**PLANNED UNIT DEVELOPMENT  
& SUBDIVISION STAFF REPORT**

**DEVELOPMENT NAME** Brandonwood Subdivision

**LOCATION** 2910 and 2916 Cottage Hill Road  
(North side of Cottage Hill Road, 60'± West of Coventry Way)

**CONTEMPLATED USE** Subdivision and Planned Unit Development Approval to allow reduced lot widths and building setbacks in a zero-lot line, single-family residential subdivision.

***Revised for the January 18<sup>th</sup> meeting:***

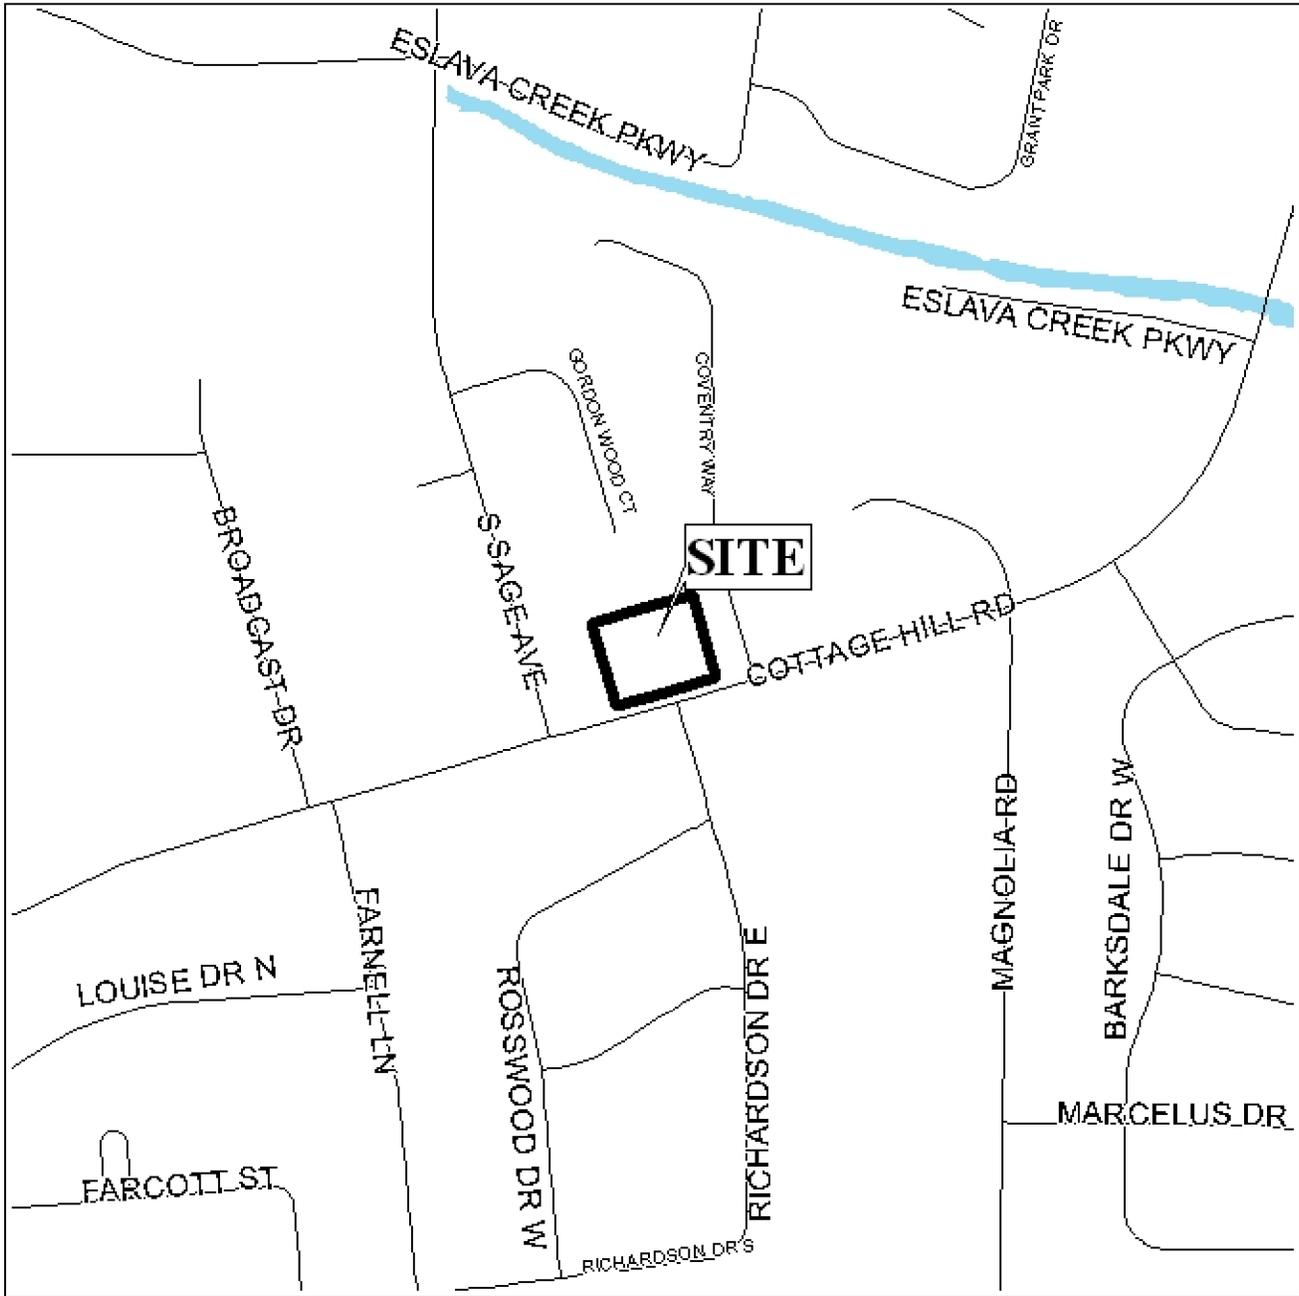
*The applicant provided a revised site plan depicting the revision of the previously submitted Subdivision Plat from 5 lots to 4 lots. The site plan also depicts the 25-foot minimum building setback lines and the required 8-foot rear yard setback lines. Therefore, since the applicant is proposing 4 lots that meet the minimum density and setbacks as required by the Zoning Ordinance and Subdivision Regulations no Planned Unit Development application would be required.*

**Subdivision:** *The plat meets the minimum requirements of the Subdivision Regulations and is recommended for Tentative Approval.*

**Planned Unit Development:** *Based upon the preceding and the revised site plan, this request should be withdrawn by the applicant.*
